101-103 BROCKSIDE LANE

AP - 103 Brookside Rd.

AP-101-103 Brookside Road Jan. 2, 1962

Plans filed on December 5, 1961 with application for a building permit for a single family dwelling, garage and enclosed swimming pool at the above named location do not contain enough information to permit us to make a complete check of these plans. We will need more information on the following listed below:

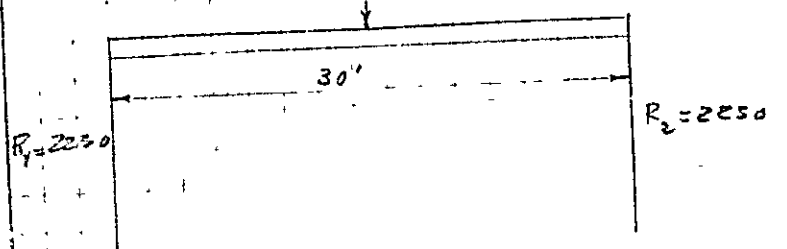
11. Material for the fire retardant separation between the garage and dwelling needs to be given. The door between the garage and basement will need ?

be a 1-3/4 inch solid core wood door with self-closing device. There is to be either a 6 inch high threshold at this doorway or a difference in elevation of 6 inches between the garage floor and the basement with the garage being at the lower elevation. Ceiling over garage is required to be of at least one-hour fire resistance.
